Subject: Dresden Station Units 2 and 3
 Quad-Cities Station Units 1 and 2
 Mark I Containment Plant Unique Analyses
NRC Docket Nos. 50-237/249 and 50-254/265

Enclosure (1): Response to NRC Questions on Mark I Short Term Program Plant Unique Analysis.

RESPONSE TO NRC QUESTIONS ON
MARK I SHORT TERM PROGRAM PLANT
UNIQUE ANALYSIS - DRESDEN UNITS 2 AND 3
(NRC DOCKET NUMBERS 50-237 AND 50-249)

RESPONSE TO NRC QUESTIONS ON
MARK I SHORT TERM PROGRAM PLANT
UNIQUE ANALYSIS - QUAD CITIES UNITS 1 AND 2
(NRC DOCKET NUMBERS 50-254 AND 50-265)

Figure 1

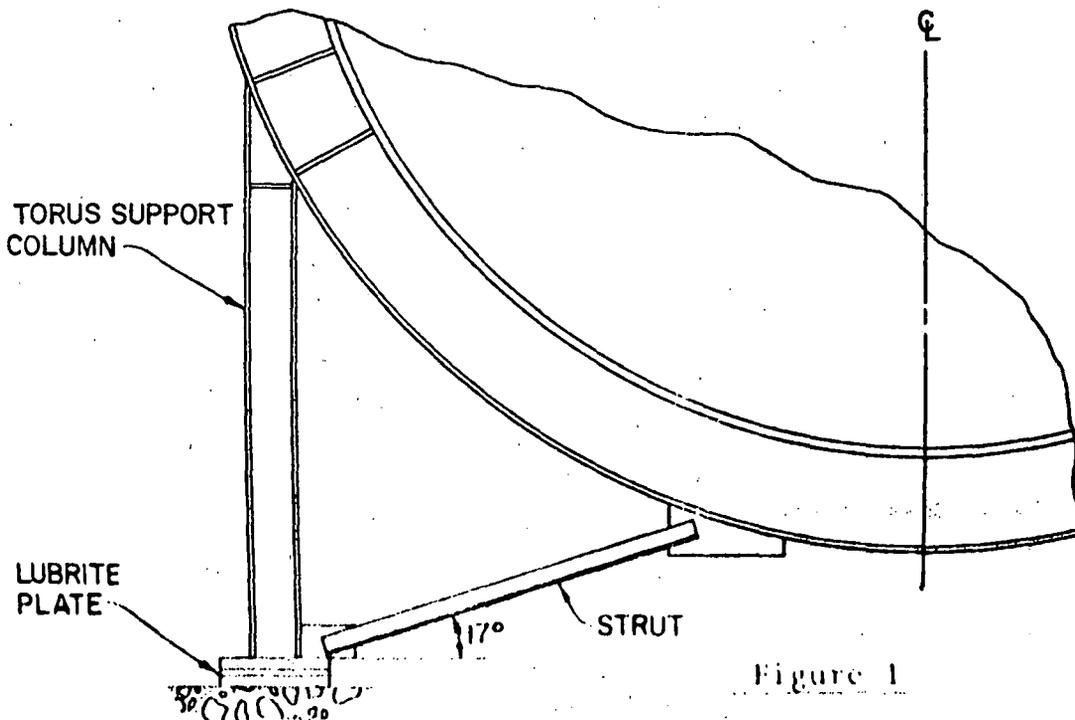
The strut between the base of the torus support columns and the lower portion of the torus shell has not been addressed in structural component evaluation reported in Reference 1 and 2 above. These components should be evaluated as part of the torus support structure.

Figure 1 below provides a general description of the subject strut and its connection to the torus support column and suppression chamber shell.

The 3-D model of the torus shell and its support system did not model the struts. However enough information is available from the 3-D model results to allow a separate evaluation of the struts. Such an evaluation has been conducted and the results are reported below.

For the evaluation of Item 2 above, it can be observed from Figure 1 that the maximum axial force that can exist in the strut is that which would cause a lateral displacement of the base of the torus support column. To determine an upper bound value for this axial load in the strut a conservatively high value for the coefficient of friction and the column load has been used. Using a value of 0.10 for the coefficient of friction and 845 kips for the column load (outside column, maximum submergence, horizontal and vertical seismic acting in compressive direction), the horizontal friction resistance is 85 kips. The upper bound value for strut axial load is therefore $85/\cos 17^\circ = 89$ kips.

The "code allowable" axial compression and tension force and the "ultimate capacity" axial compression and tension force for the strut have been calculated for comparison with the 89 kips computed above. The code allowable axial compressive load is 110 kips and is controlled by strut buckling considerations. The code allowable axial tension load in the strut is 111 kips and is controlled by the connection of the strut to the base of the torus support column. The ultimate capacity value for the tension and compression force in the strut is 251 kips and is controlled by the connection of the strut to the column base. Based on the above it can be concluded the axial forces in the strut will not exceed code allowables during the pool swell transient.

To answer the question posed in Item 3 above, the horizontal and vertical displacements at the point that the strut attaches to the shell have been extracted from the 3-D analysis results. It has been determined that these displacements are such that the strut will impose a lateral displacement at the base of the column. The maximum displacement of the base of the column occurs for the inside torus support column. This horizontal displacement of 0.067 inches results from a downward displacement of the strut-to-shell attachment point of 0.114 inches with a corresponding horizontal displacement (radially inward toward the centerline of the drywell) of 0.032 inches. The 0.067 inch lateral displacement results in a maximum bending moment in the torus support column of 420 in-kips. As reported

In summary; the strut has been evaluated for the effects of pool swell loads on the torus shell and it has been determined that forces in the strut and its connections will remain within code allowables. The effects of strut forces on the torus support columns are insignificant. Therefore the strength ratios and conclusions reported in References 1 and 2 remain unchanged.
